Mineshaft Treatment Adjacent to Proposed Adoptable RoadDesign Philosophy

TITLE			SHEET
SPECIFICATION FOR ROADWAYS and ANCILLIARY ITEMS			16 of 20
			REVISION

RE: GRANGO LANE PONCIAU: ROAD TREATMENT

Plan on Adoptable Road Construction

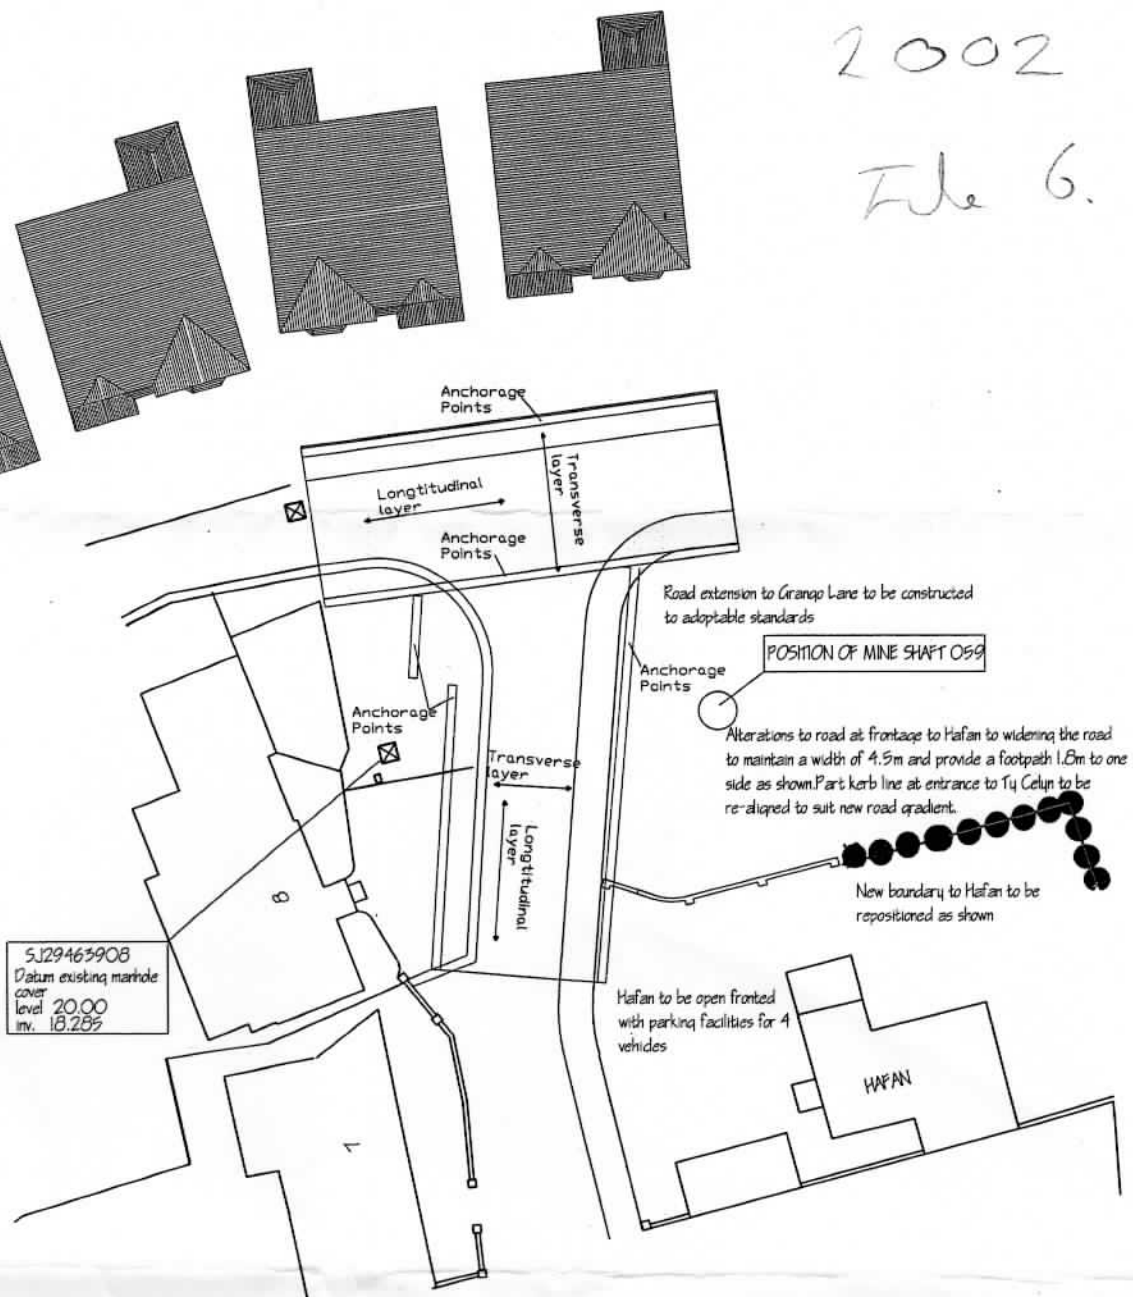
Regarding your sketch for the road treatment (attached), which we understand is to protect the road from the potential collapse of Mine Shaft 529.

The shaft is shown some 3m from the edge of the road. The shaft has been proven to be in a different position than that indicated by the Coal Authority, and we are convinced that the location is correct, as it has been plotted from the primary source information, which was the 1:500 scale Public Health plans dated 1850.

The rock head in this area has been proven to be at a depth of 3m, with a thin cover of glacial till. Therefore, even should the shaft collapse the collapse feature, assuming a collapse of 45°, which is considered to be conservative, is unlikely to reach the road. In any case, the treatment shown on the attached figure is more than adequate to protect the road in the short term to allow treatment of the collapsed shaft.
